# TECHNICAL BULLETIN

[Issue No.] FA-A-0040

[Title] Changes in the appearance of the A1S68AD  
analog-digital converter module

[Relevant Models] A1S68AD

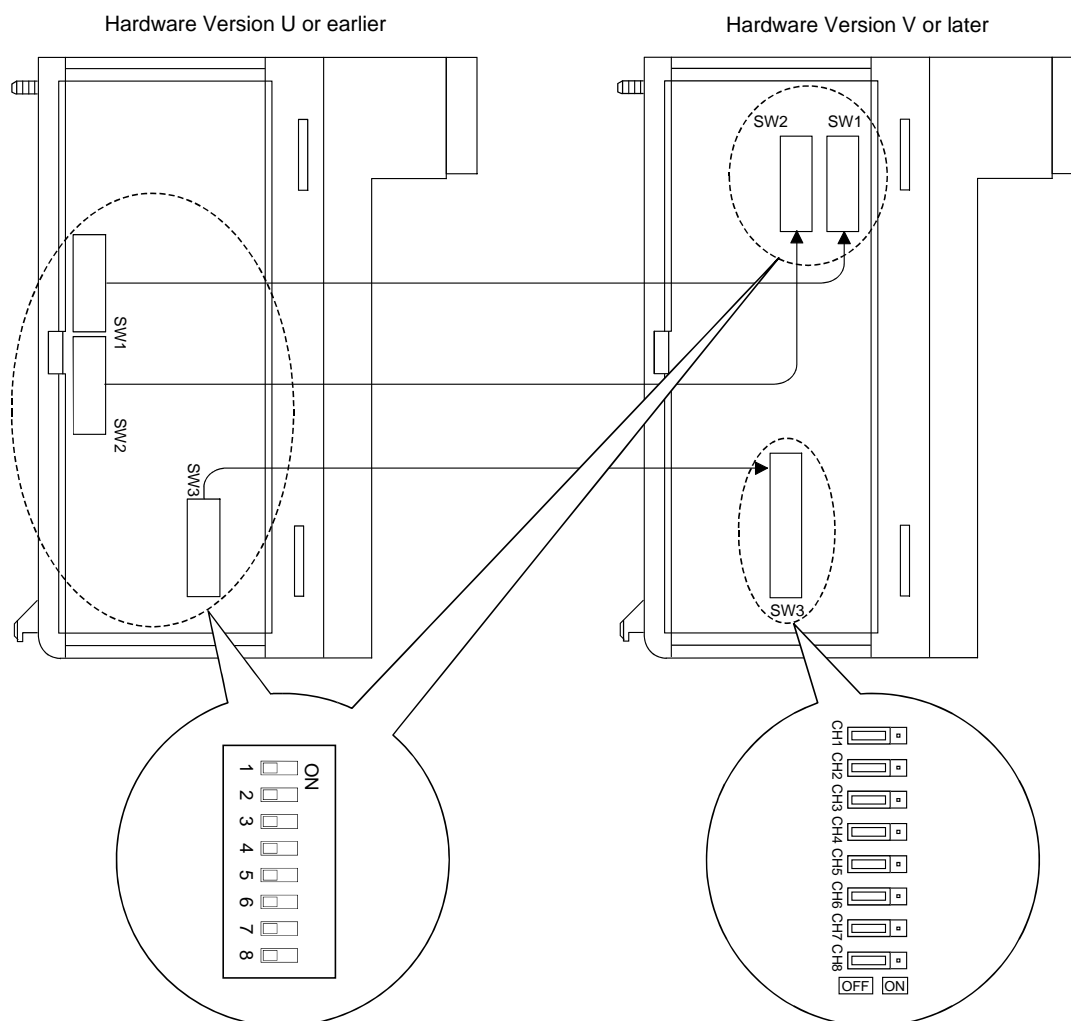
Along with the trend toward downsizing and high integration of module components and in consideration of the future availability, a part of the A1S68AD analog-digital converter module components has been changed. Also, some component positions have been changed.

- (1) The positions of the input range selector switches have been changed.
- (2) The component of the input range selector switch SW3 and its setting method has been changed. The setting details are the same as those of the former models.

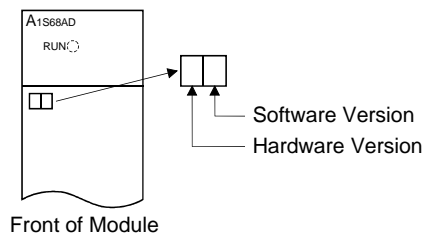
On page 4 of the manual included with the product (IB(NA)-0800371-A), the ON/OFF indication of the input range selector switch SW3 is shown incorrectly. Please confirm the incorrect and correct illustrations provided below.
